Number: FS-2013-03

Subject: Exhaust System Flex Pipe Change

Gillig is issuing FS-2013-03 to replace the exhaust flex pipes listed below with a new Truflex NTSD, (stainless steel wound):

For the installation of the Tru-Flex all metal, braid reinforced NTSD exhaust bellows on 2007-2013 year engine equipped buses.

FIGURE 3. ISL-G CNG ENGINE

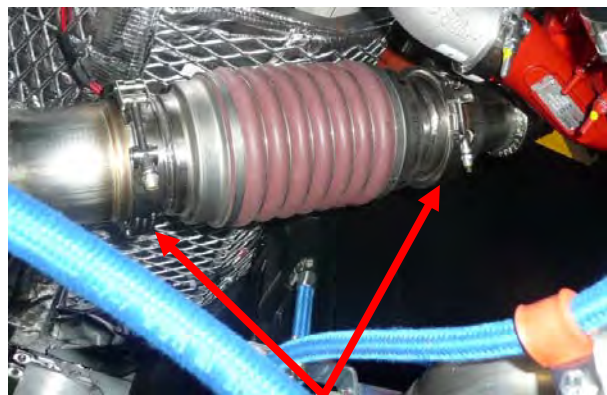
LOOSEN V-BAND CLAMPS SHOWN TO REMOVE THE EXISTING BELLOWS (CLAMP LOCATION "C")

NOTE: LINKEO BELLOWS SHOWN, BTLI AND NTSD REMOVAL IS SIMILAR.

1. Remove the existing exhaust bellows from the bus by loosening the two V-Band clamps.

FIGURE 6.

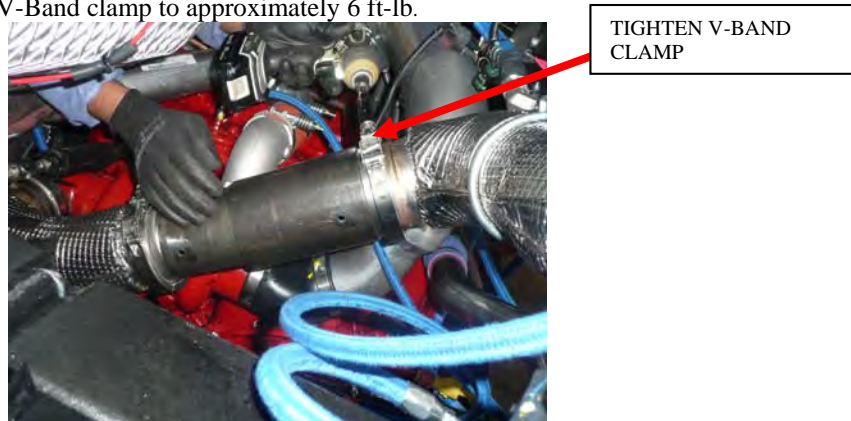
2. Insert the alignment tool between the turbo outlet pipe & muffler inlet pipe (as shown below), tighten the bottom V-Band clamp to approximately 6 ft-lb and align the other end of the tool with muffler inlet pipe. **NOTE: DO NOT FORCE THE ALIGNMENT TOOL TO FIT.**

3. Then tighten the upper V-Band clamp to approximately 6 ft-lb.

If alignment tool fits between the pipes with V-Band clamps installed to approximately 6 ft-lb, remove the alignment tool, measure/verify length and install new all metal bellows (jump to step 9).
If alignment tool does not fit then continue to step 4.

FIGURES 8 & 9. ISB DIESEL HYBRID ENGINE SHOWN

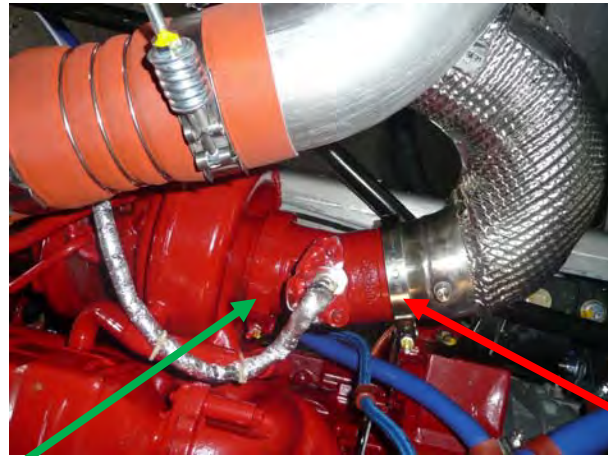
TURBO OUTLET PIPE INLET V-BAND CLAMP (CLAMP LOCATION "B")

CAST ELBOW AT TURBO OUTLET V-BAND CLAMP (CLAMP LOCATION "A")

4. To access the turbo outlet pipe V-Band clamps, remove the settee hatch from inside the bus.
5. Loosen both Cummins cast turbo outlet elbow V-Band clamp and exhaust turbo outlet pipe V-Band clamp through the settee hatch access.

- CAST TURBO OUTLET ELBOW V-BAND CLAMP *LOCATION "A", SEE FIGURES: 8 & 9 FOR ISB on page 4
10 & 11 FOR ISL on page 4
12 & 13 FOR ISL-G on page 5*
- EXHAUST TURBO OUTLET PIPE V-BAND CLAMP *LOCATION "B", SEE FIGURES: 8 & 9 FOR ISB on page 4
10 & 11 FOR ISL on page 4
N/A for ISL-G*
- ALIGNMENT TOOL UPPER & LOWER V-BAND CLAMPS *LOCATION "C", SEE FIGURE 16 BELOW*
- MUFFLER INLET PIPE V-BAND CLAMP *LOCATION "D", SEE FIGURES: 14 FOR ISB on page 5
14 FOR ISL on page 5
15 FOR ISL-G on page 5*
- MUFFLER INLET PIPE U-CLAMP *LOCATION "E", SEE FIGURES: 14 FOR ISB on page 5
14 FOR ISL on page 5
15 FOR ISL-G on page 5*

FIGURES 12 & 13. ISL-G CNG ENGINE SHOWN

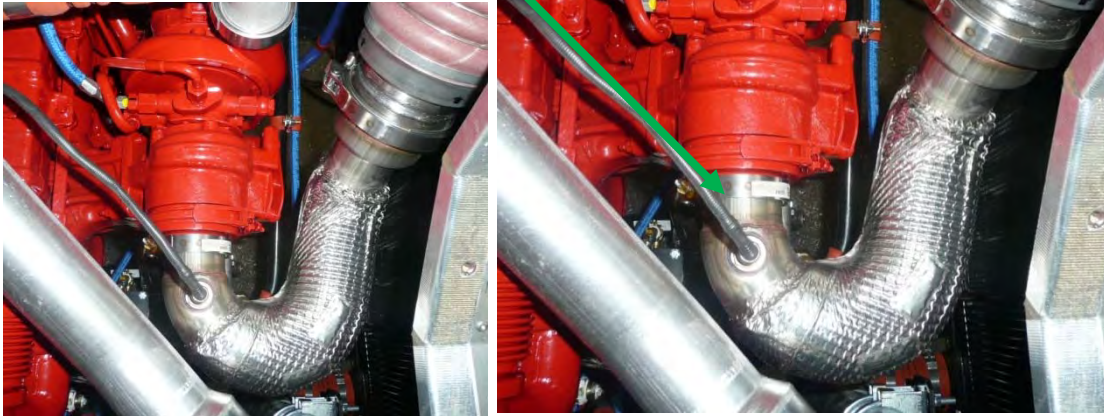
TURBO OUTLET PIPE
INLET V-BAND CLAMP
(CLAMP LOCATION "B")

FIGURE 14. ISB/ISL DIESEL ENGINE SHOWN

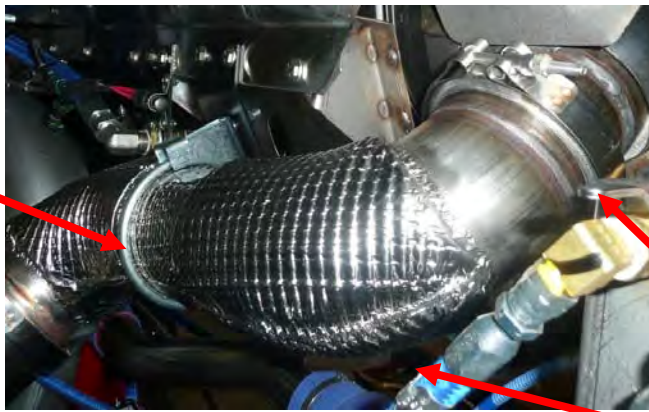
6. Loosen the V-Band & U clamps on exhaust muffler inlet pipe. Loosening the clamps will allow the pipes to move into alignment.

U-CLAMP
(LOCATION "E")

MUFFLER INLET
V-BAND CLAMP
(CLAMP LOCATION "D")

FIGURE 15. ISL-G CNG ENGINE SHOWN

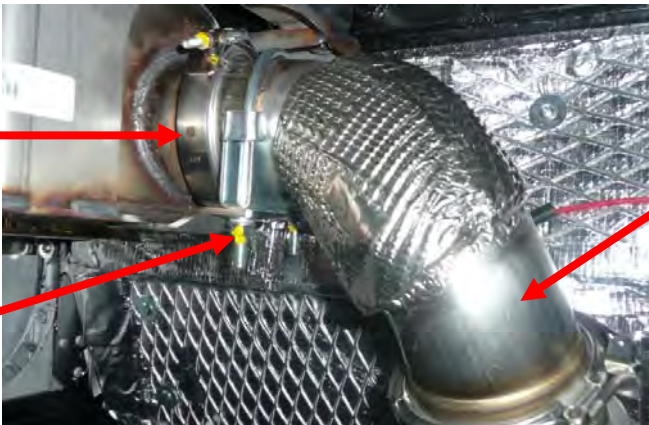
MUFFLER INLET
V-BAND CLAMP
(CLAMP LOCATION "D")

EXHAUST MUFFLER
INLET PIPE

FIGURE 17. Bellows Length Measurement Location.

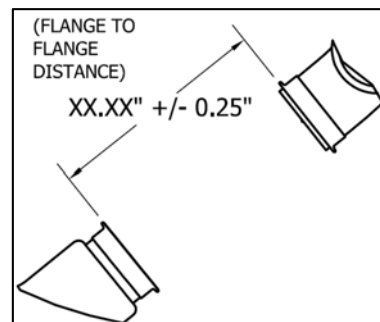
8. After torquing all the clamps to 13+/- 0.5 ft-lb, remove the alignment tool by loosening upper & lower V-Band clamps.
9. Measure the length of the gap between the two exhaust pipe flanges and verify the length is within the allowable range for the specific bellows to be installed. Refer to the table below and Figure 17 for the appropriate dimension.

Tru-Flex NTSD P/N	Flange to Flange Distance (inches)
01-71799-000	12.00 +/- 0.25
01-71800-000	12.25 +/- 0.25
01-71759-000	14.00 +/- 0.25
01-71801-000	16.00 +/- 0.25

10. If the flange to flange distance is not correct, repeat steps 2-9. If the correct flange to flange distance cannot be obtained, contact Gillig Field Service.
11. Insert new all metal NTSD exhaust bellows between the turbo outlet pipe & muffler inlet pipe noting the flow direction labeled on the bellows, and then torque bellows V-Band clamps to 13+/- 0.5 ft-lb.
12. After completing the installation:
 - Confirm the exhaust bellows is not damaged or interfering with surrounding components.
 - Start the engine and check for exhaust leaks.
 - Reinstall the settee hatch (if removed).
